Groundwater Application Review Summary Form

Application # G- 19290

GW Reviewer Stacey Garrison/Travis Brown Date Review Completed: 10/29/2024

SUBJECT: Scenic Waterway Interference Evaluation

Theis Drawdown Analysis**POA 1**

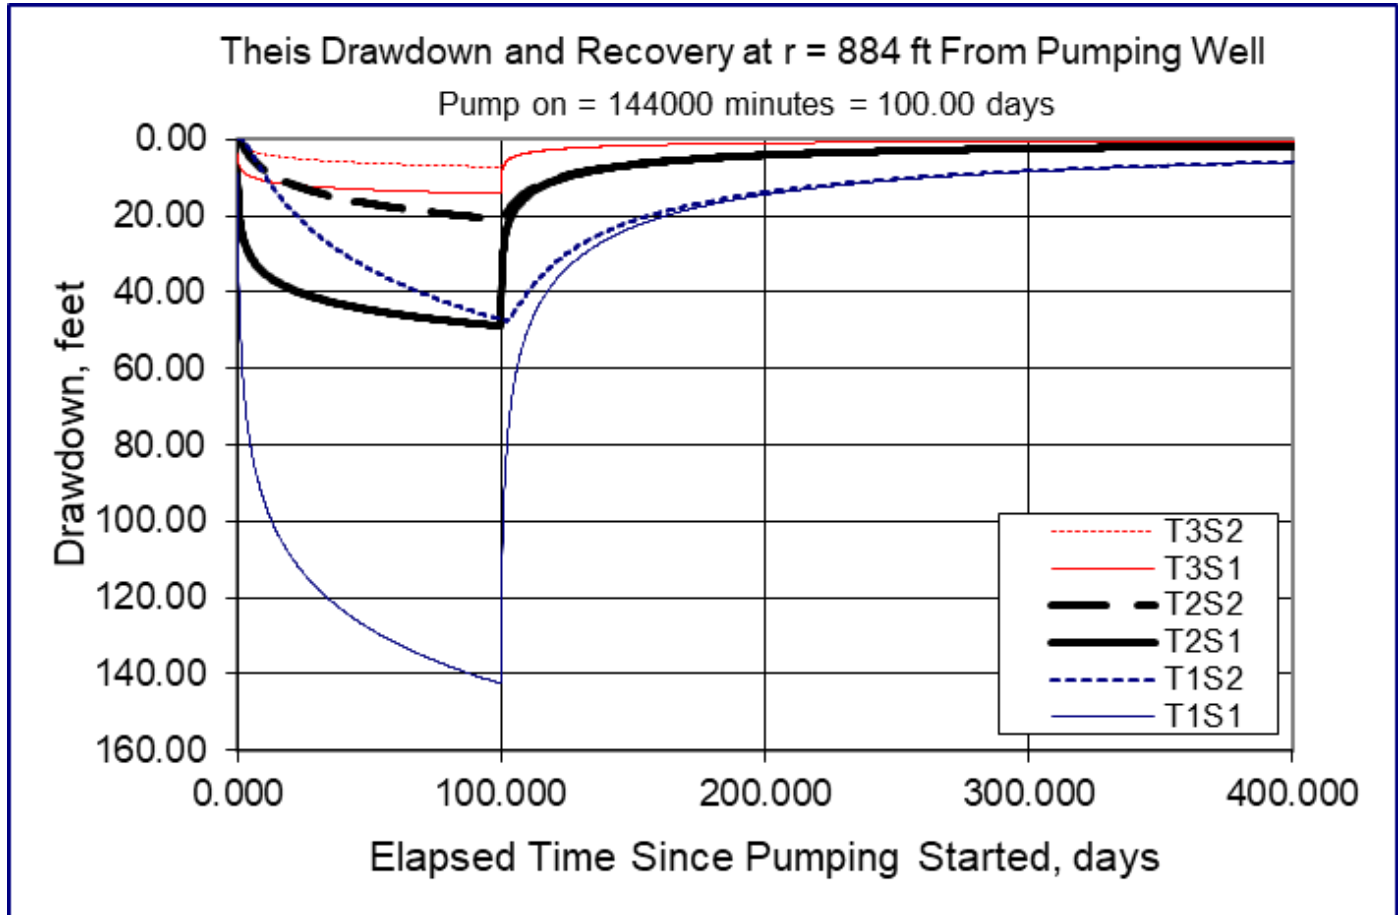
The nearest groundwater user to POA 1 is the exempt domestic well serving tax lot 1102 at 29961 Whiskey Hill Road, 884 ft north of the POA at an elevation of ~182 ft msl. A well log could not be associated with this tax lot or address but is likely given the identification of well logs associated with other domestic tax lots in this area (CLAC 66381, CLAC 12673, CLAC 63180, CLAC 12675, CLAC 12675). It is likely the proposed use would cause some degree of well-to-well interference with the domestic well for tax lot 1102. To assess the degree of drawdown, a Theis drawdown analysis was conducted for the proposed use (see attached Theis Drawdown Analysis-POA 1). Results indicate that the proposed use is not likely to cause

well-to-well interference with the well for tax lot 1102 that exceeds the threshold under the standard condition for alluvial aquifers in the Willamette Basin.

Radial distance from pumping well (r)=884 ft [estimated radial distance to nearest user, tax lot 1102]

Pumping Rate (Q)= 0.946 cfs (~424.6 gpm)

Aquifer Transmissivity (T_1)= 2,318 gpd/ft (310 ft²/day), (T_2)= 7,992 gpd/ft (1,068 ft²/day), (T_3)= 32,059 gpd/ft (4,286 ft²/day)

Storativity (s_1) = 0.0001, (s_2) = 0.01 [Conlon et al 2005, Table 2 values for Middle Sedimentary Unit]

Total pumping time=100 days*

*The full pumping rate could not be utilized continuously for the entire 245-day period of use without exceeding the 189.25 ac-ft maximum allowed duty. For the maximum allowed duty of 189.25 ac-ft, continuous pumping would occur for 100 days at a rate of 0.946 cfs (~424.6 gpm).

POA 2

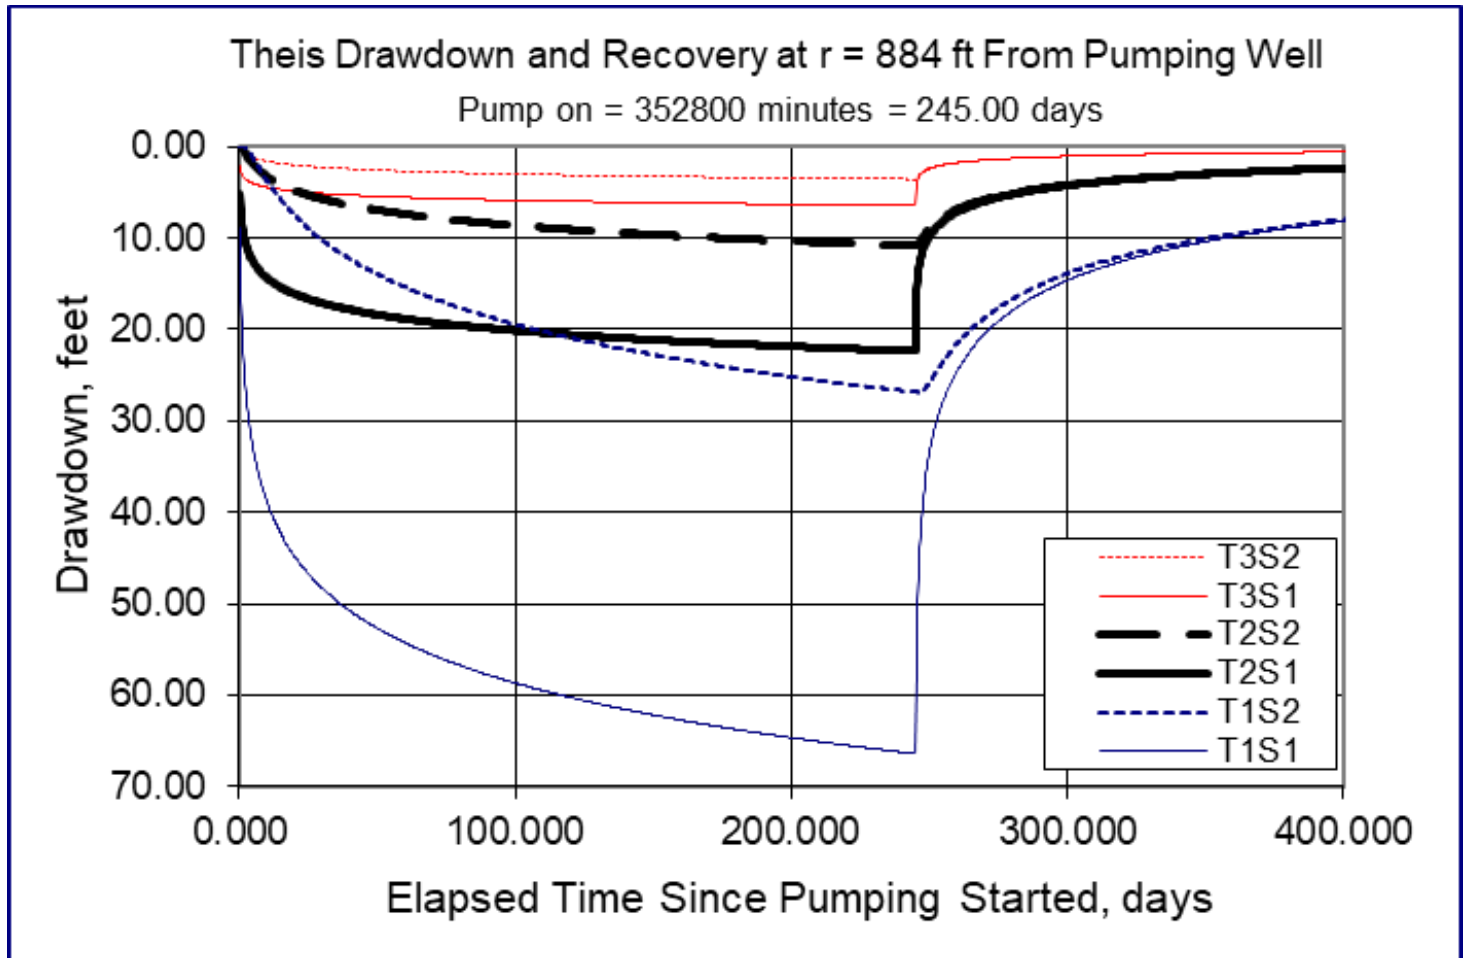
The nearest groundwater user to POA 2 is CLAC 12675 (an exempt domestic well), 463 ft north of the POA at an elevation of ~175 ft msl. CLAC 12675 is sealed to a depth of 19 ft [156 ft msl] with a WBZ from 110 to 124 ft bls [51 to 65 ft msl] and drilled to a depth of 124 ft bls [51 ft msl]. It is likely the proposed use would cause some degree of well-to-well interference with CLAC 12675. To assess the degree of drawdown, a Theis drawdown analysis was conducted for the proposed use (see attached Theis Drawdown Analysis-POA 2). Results indicate that the proposed use is not likely to cause well-to-well interference with CLAC 12675 that exceeds the threshold under the standard condition for alluvial aquifers in the Willamette Basin.

Radial distance from pumping well (r)=463 ft [estimated radial distance to nearest user, CLAC 12675]

Pumping Rate (Q)= 0.38945 cfs (~174.8 gpm)*

Aquifer Transmissivity ($T1$)= 2,318 gpd/ft (310 ft²/day), ($T2$)= 7,992 gpd/ft (1,068 ft²/day), ($T3$)= 32,059 gpd/ft (4,286 ft²/day)

Storativity ($s1$) = 0.0001, ($s2$) = 0.01 [Conlon et al 2005, Table 2 values for Middle Sedimentary Unit]

Total pumping time=245 days

*The full pumping rate could not be utilized continuously for the entire 245-day period of use without exceeding the 189.25 ac-ft maximum allowed duty. For the maximum allowed duty of 189.25 ac-ft, continuous pumping would occur for 245 days at a rate of 0.389445 cfs (~147.78 gpm).
